Thomas D. Ray, P.E.
Site Vice President
McGuire Nuclear Station

July 3, 2018
Serial No. MNS-18-036

Duke Energy Carolinas, LLC
McGuire Nuclear Station, Units 1 and 2
Docket Nos. 50-369 and 50-370
Renewed License Nos. NPF-9 and NPF-17

Subject: Response to the Request for Additional Information regarding the License Amendment Request to Revise the Licensing Bases for Protection from Tornado-Generated Missiles

Figure 3: MNS Tornado Hazard Curves and Illustration of Enhanced EF5 Frequency

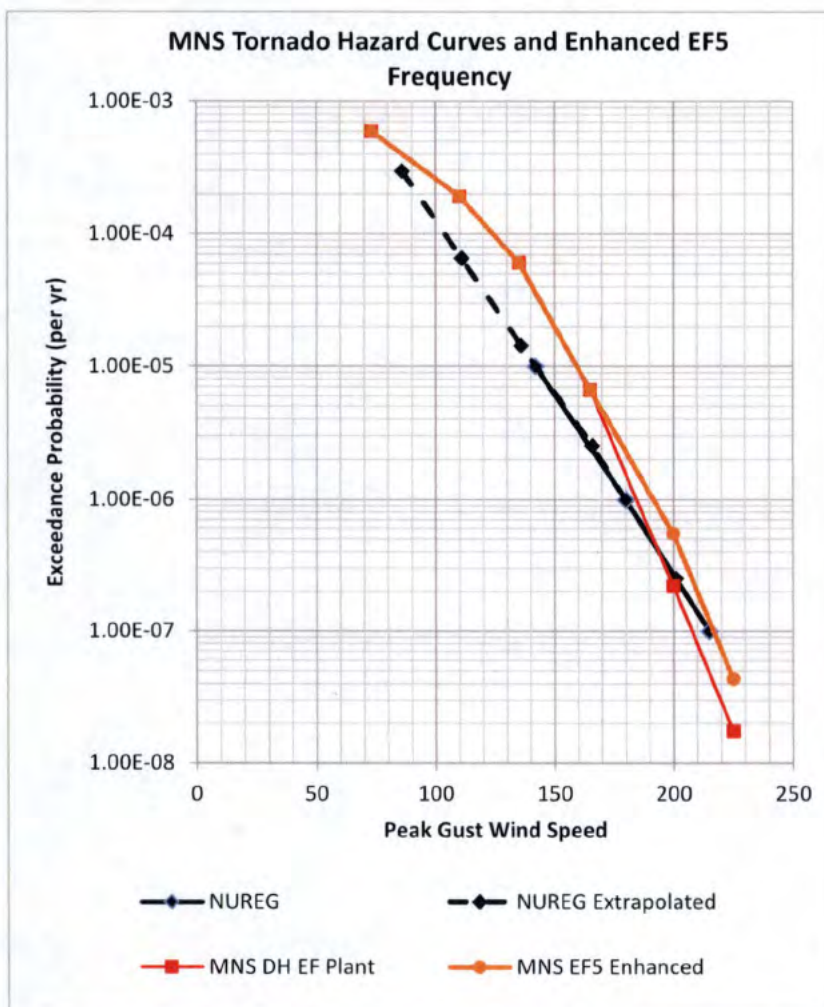
The site specific analysis for development of the tornado hazard curve for McGuire is based on data from the National Oceanic and Atmospheric Administration (NOAA) Storm Prediction Center. As shown in Figure 3-2 of the submittal, the TORMIS developed McGuire tornado hazard curves, i.e., the TORRISK 200 x 200 curve, are used and compared to NUREG/CR-4461, Revision 2, "Tornado Climatology of the Contiguous United States" (ADAMS Accession No. ML070810400), to demonstrate conservatism. However, in Enclosure 1, page 21 of the LAR, it states "It can be seen that the NUREG EF [Enhanced Fujita] curve is below the TORRISK 200 x 200 curve until 180 mph, where they intersect." As such, tornado frequency shown in the tornado hazard curve appears non-conservative beyond 180 miles per hour (mph).

The NRC staff requests the licensee to confirm that values used above 180 mph are conservative and bounding values and provide justification.

LAR Figure clarification. The plant safety envelop curve (labeled as MNS DH EF Plant in Enclosure 1, Figure 3-2 of the LAR) was used for the MNS TORMIS plant tornado missile simulations. This curve crosses the NUREG EF MNS curve (NUREG/CR-4461) at about 193 miles per hour (mph) as opposed to 180 mph. Figure 3-2 of the LAR compared the MNS DH EF 200 foot (ft) by 200 ft curve and the MNS DH EF Plant curve to the NUREG EF MNS curve however the 200 ft by 200 ft curve was not used in the MNS simulations.

1. The first sensitivity analysis is to quantify the effect of the NUREG EF MNS curve on the MNS TORMIS missile damage frequencies. This is illustrated in **Figure 3** using the NUREG EF MNS curve with extrapolations to lower wind speeds. Just as TORMIS simulates individual EF intensities and aggregates the results to get the overall missile damage frequencies, the contribution by EF scale was computed using the NUREG EF frequencies. This approach provides an analytical quantification using the TORMIS results with the NUREG EF MNS curve. As illustrated in **Table 5**, missile damage frequency results that are more than a factor of three lower than the MNS DH EF Plant curve results as documented in the LAR. The significantly higher TORMIS frequencies for EF1-EF4 (as shown in **Table 4**) contribute to this result. Hence, by virtue of comparing these results, the MNS DH EF Plant curve produces MNS missile damage frequencies that are approximately 300% higher than those that would be produced using the NUREG EF curve.

2. The second sensitivity evaluates the EF5 frequencies, which corresponds to wind speeds greater than 201 mph. The TORMIS EF5 frequency was multiplied by a factor of 2.5 in order to create a TORMIS hazard curve that is above the NUREG for the full range of EF5 wind speeds, then updated damage frequencies were produced keeping all other TORMIS frequencies the same (see the orange curve in Figure 3 labeled “MNS EF5 Enhanced”). For this case, the aggregate damage frequency increased by about 4% for each Unit, as shown in Table 5. Hence, the effect of increasing EF5 frequencies produced a minimal impact on the MNS missile damage frequencies. This result follows from the previous results illustrate that the contributions to the missile damage frequencies from much more frequent, but lower intensity tornadoes, dominates the tornado missile risk for MNS.
